Technical Document LA24023

Application under the *Agricultural Operation Practices Act* for a confined feeding operation, manure collection area, and/or manure storage facility(ies)

NRCB USE ONLY	Application number	Legal land description
	<input checked="" type="checkbox"/> Approval <input type="checkbox"/> Registration <input type="checkbox"/> Authorization <input type="checkbox"/> Amendment	LA24023

**Re: Geotechnical Review and Evaluation
NRCB Permitting of Proposed Pens & Catch Basin
NW-16-009-25-W4M, near Fort Macleod, Alberta**

Catch Basin Storage Volume Calculator

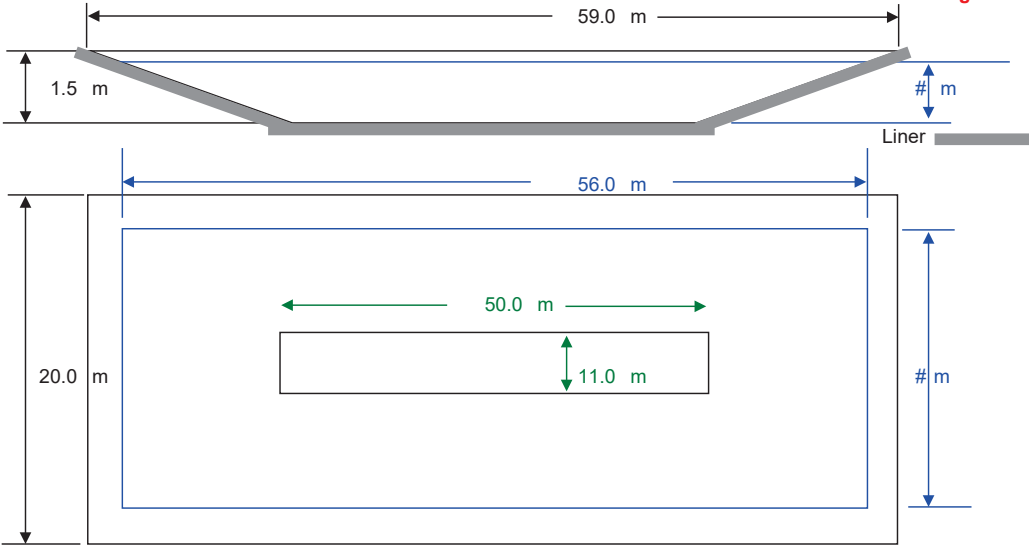
Catch basin calculator. Total volume @ freeboard level: 745 m³ Runoff capacity requirements met: YES NO

Figure 1
Shorehole Locations
Proposed Pens & Catch Basin
Peyer Feeders Ltd.
MSP File: BX30740
February, 2023

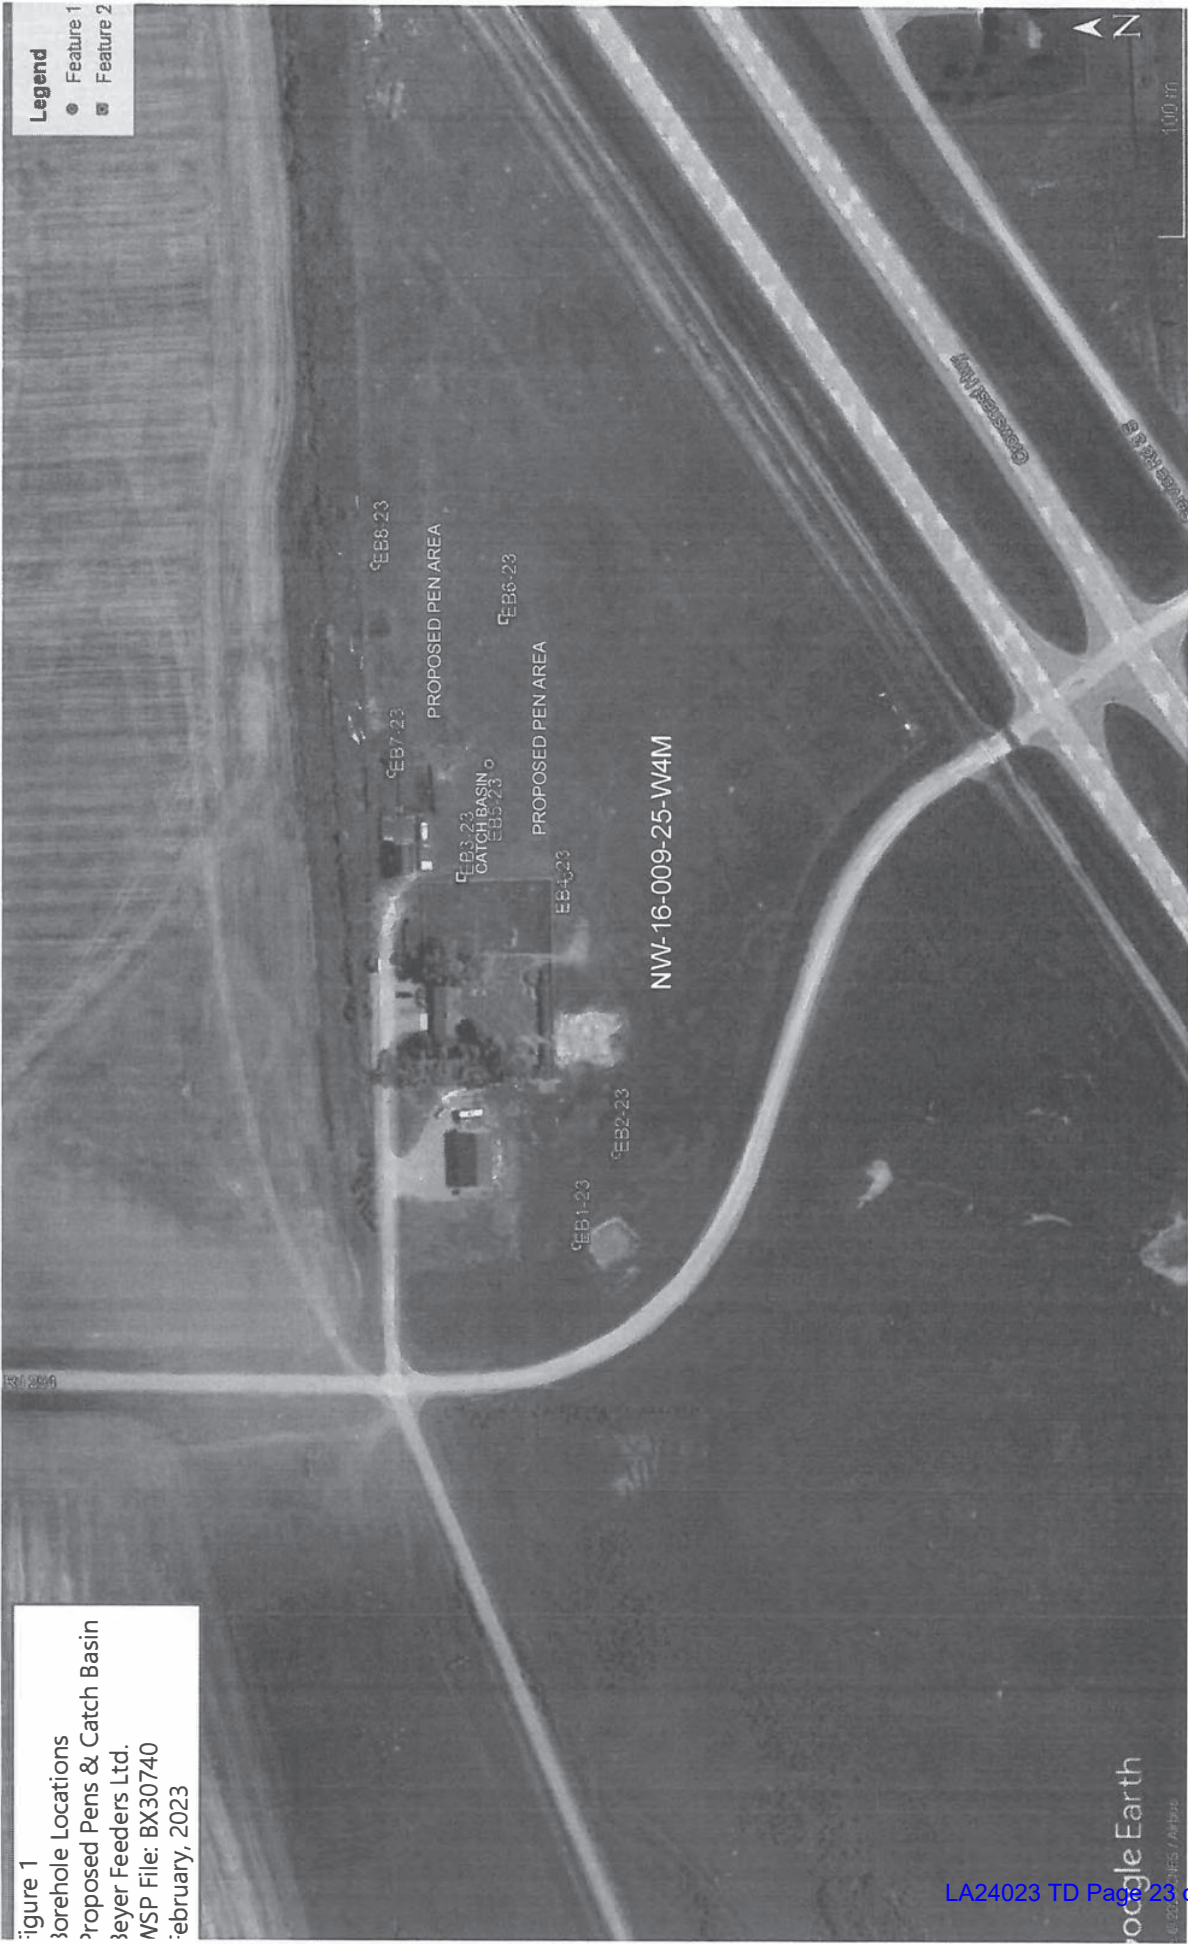
The geotechnical review indicated variable soil conditions across the site, and sand lensing / saturated conditions at many of the borehole locations in the proposed area of the proposed facilities. The underlying topography slopes to the west and northwest towards the Old Man River, indicating the groundwater flow moves towards well 256433.

Borehole EB3-23 (catch basin location) had saturated sand lenses at 5.0 meters (water table below 6.3 m). A condition will be included in the permit requiring the applicant to have any sand lenses encountered during the expansion of the catch basin over-excavated and backfilled with clay material.
